USSN. 09/533,215
Examiner: SHAFFER, RICKY D
Group A.U.: 2872

Amendments to the Drawings:

Remarks.

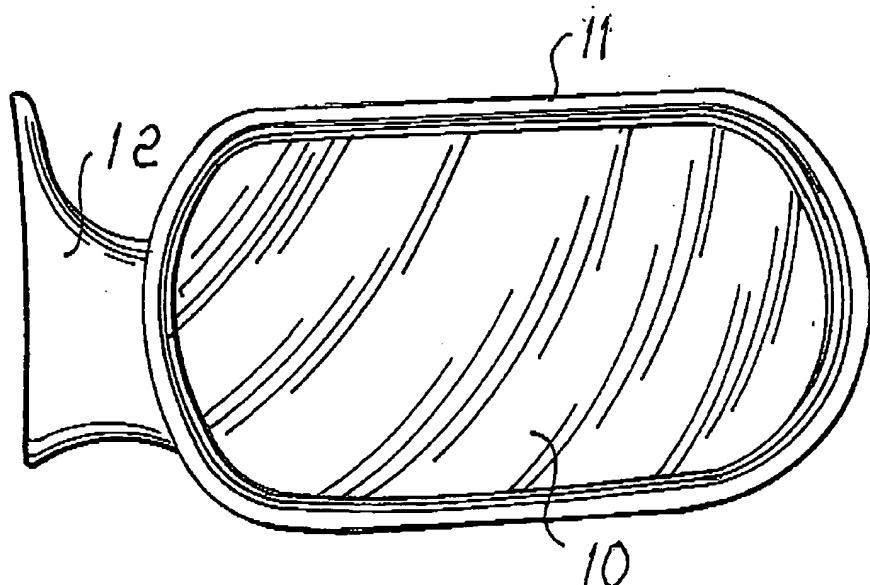
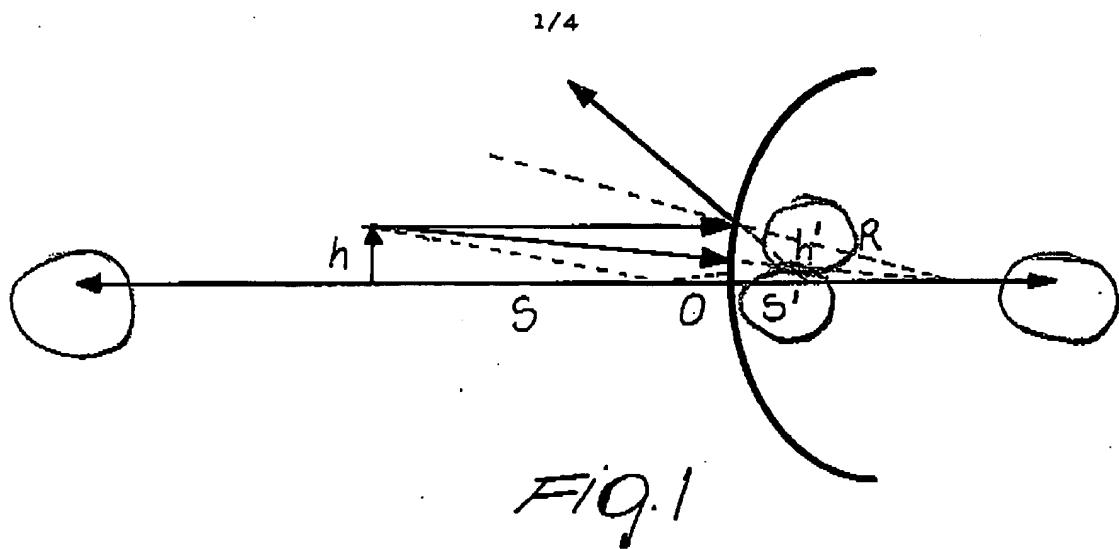
In Fig. 1, the reference signs p and q, not mentioned in the specification, have been deleted without prejudice. The reference S' and h' have been correctly indicated as requested.

FIG. 4

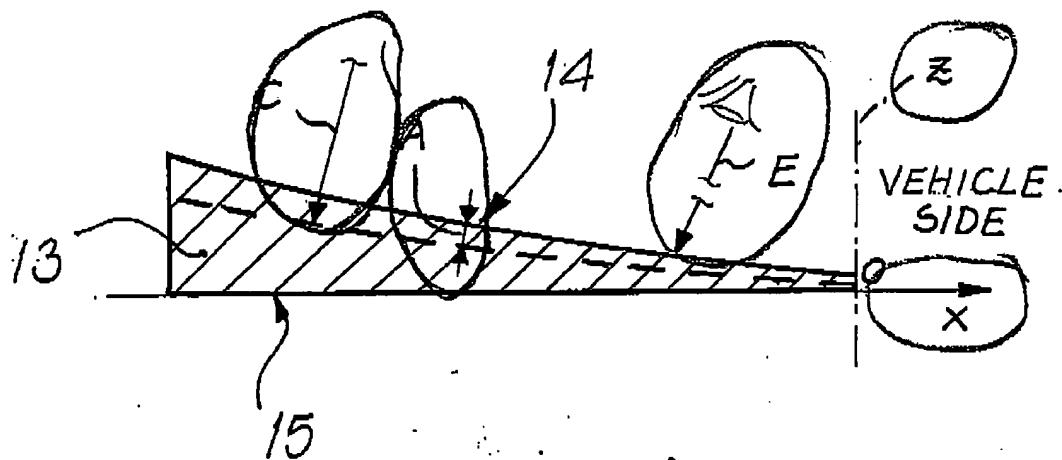
Amended drawing Figure 4 is identical to the originally filed one but for the addition of indications to the references C, A, E and z, in compliance with the observations in the Final Rejection.

In Fig. 4 the origin O, axes X and Z and curvature C and distance E have been indicated consistent with the specification.

FIG. 6

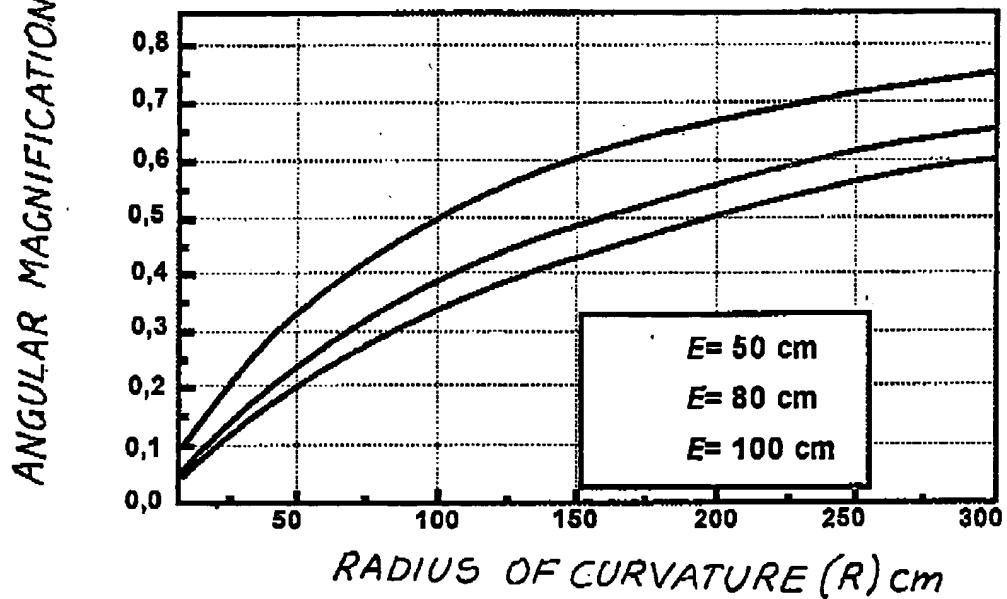
In Fig 6 the reference V has been changed to the correct M, in agreement with the

specification and the indication of the very diagram (angular magnification).
